PART 1 AIRWORTHINESS "AGGRO" (please add to the 1982 Blue Pages)

To all owners -  
TN 8/9/82

SUBJECT :  
1. Elevator drive.  
2. Tail parachute.  
3. Horizontal tailplane.  
4. Amendments of the Flight and Service Manual.

AFFECTED SAILPLANE :  
Sailplane Cirrus, FRG Type Certificate No. 265,  
Variants Cirrus and Cirrus VTC, all Serial Numbers.

Cover plate for locking the tail parachute  
operating handle .

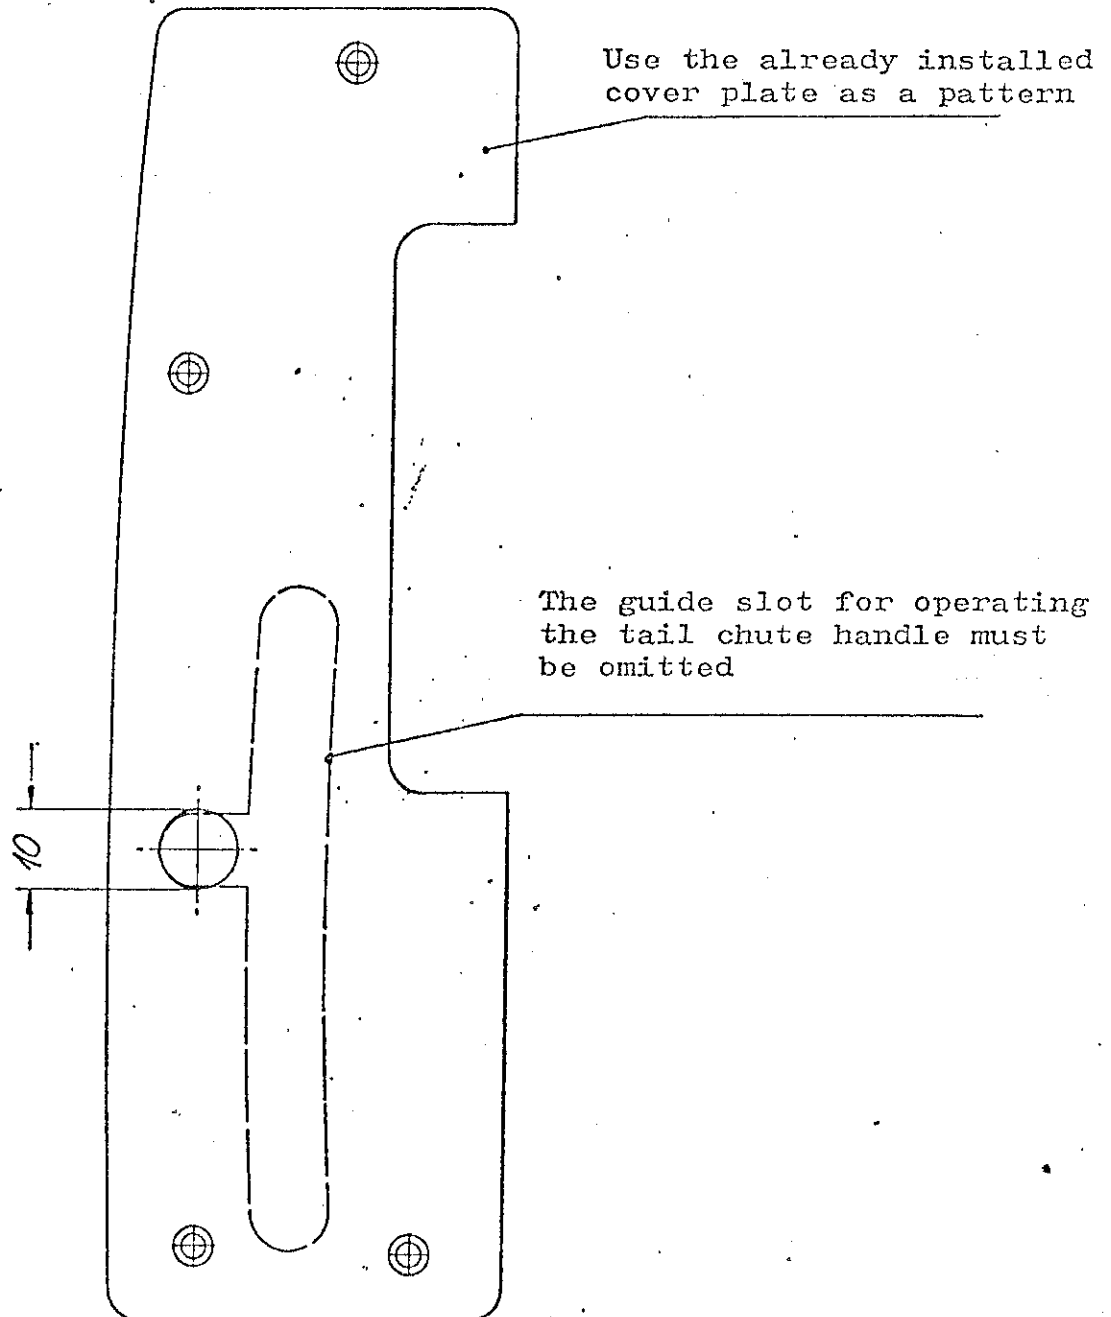
- a) Lock the operating handle for the tail chute in the cockpit as shown on the sketch, page 4 of this Note.
- b) Screw off the blue ball knob.
- c) Remove the reference placard for tail chute operation, if any.
- d) Check the tail chute box for a drainage hole (dia 6 mm).
- e) Amendments of the Flight and Service Manual:

**Material:**

Aluminum alloy half-hard - hard AlMg1  
sheet 1.5 mm thick

Safety pin hole  
against the lower  
face of the top  
boom lug fitting.

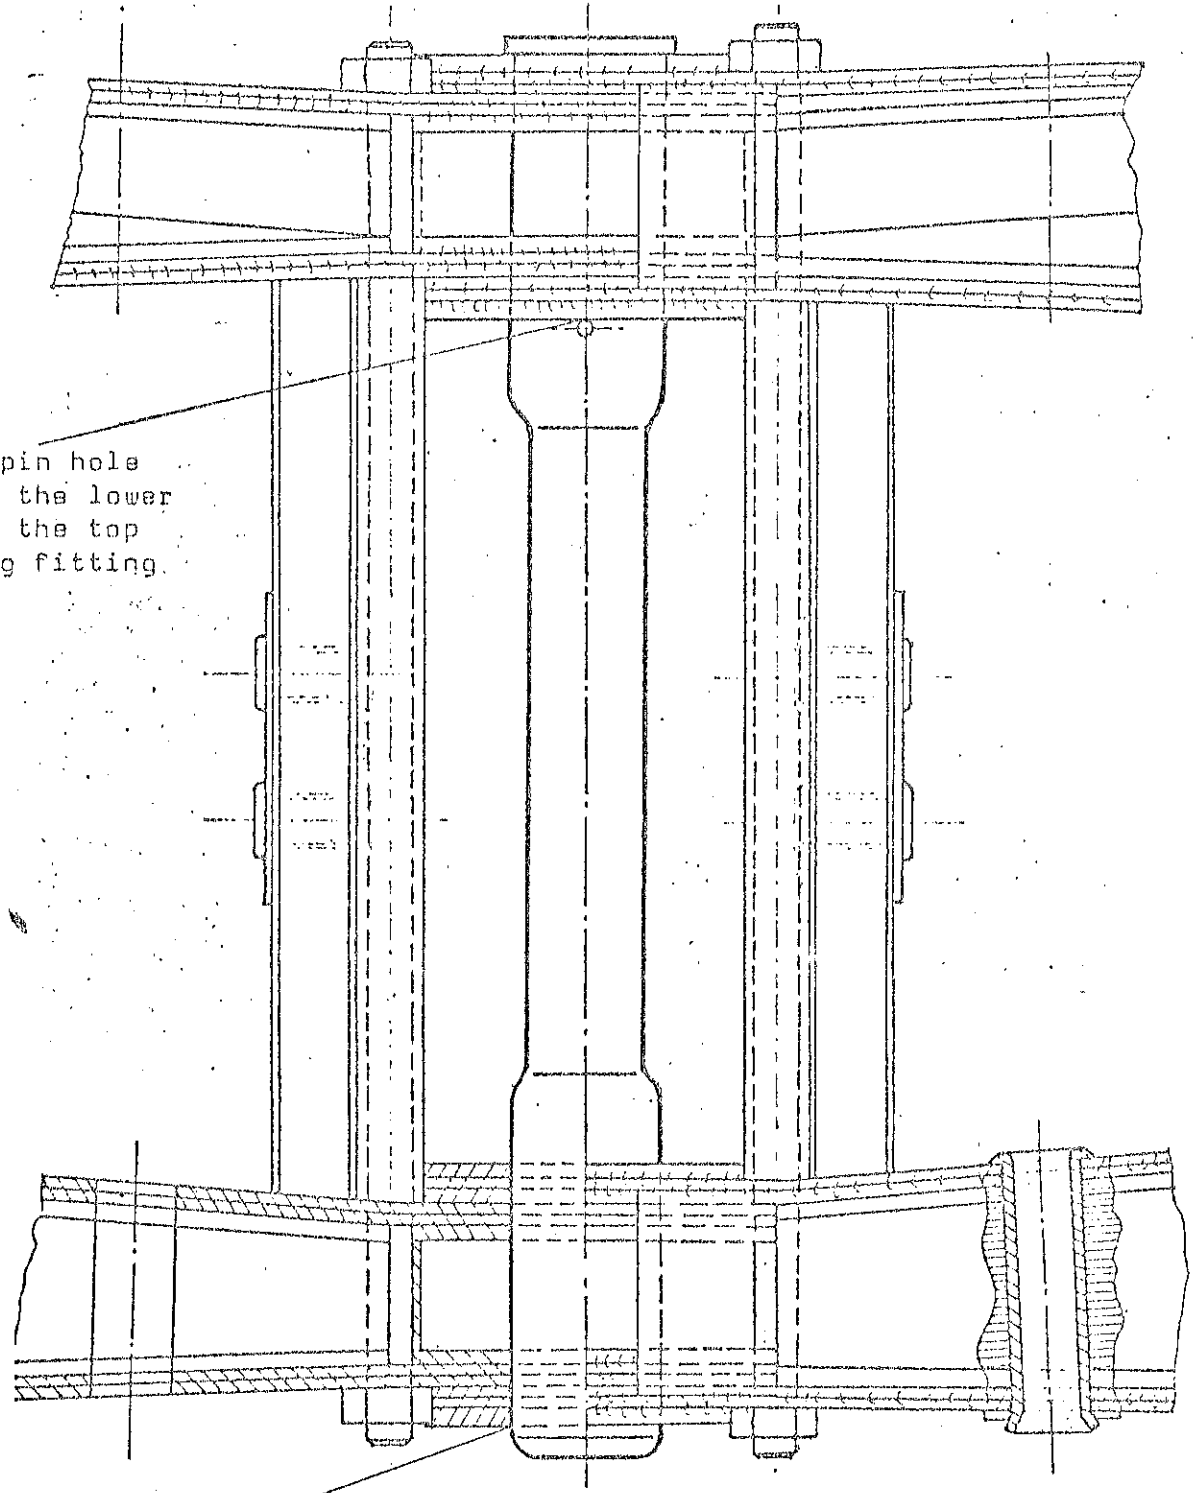
1. It must be checked that the main rigging pin is fully through the bottom lug fitting. With the main rigging pin pulled fully upwards by means of the tee handle, such that the 2.5 mm safety pin is hard against the lower face of the top boom lug fitting, inspect the amount of plain portion of main pin shank protruding below the port bottom boom lug fitting (Wings imburdened). If difficulty in the inspection is encountered when the Motorglider is assembled due to poor access, the wings must be removed and port wing inspected. Certainly upon the following assembly the inspection must be made again (when necessary, by help of a mirror and a handlamp).  
Should no plain shank be visible protruding below the port bottom lug fitting, according to 1., the aircraft shall not fly until the cause has been established, and rectified. For that, contact the manufacturer Fa. Scheibe Flugzeugbau.

2. Normally the main rigging pin has one safety pin hole. If more than one safety pin hole exists the aircraft must not be flown until the correct hole has been established, and the redundant hole made unusable (flush rivet)

If the inspection according to 1., shows that the main rigging pin is not fully through the bottom lug fitting with the plain portion, the first thing is to check that, with the main rigging pin fully down, another safety pin hole could be made, so that the plain portion is through the bottom lug fitting. Another thing to check is that the female lug fittings has not been splayed through a wrong assembly. In case the fittings must be straightened and a new inspection according to 1., must be made, contact Fa. Scheibe Flugzeugbau.
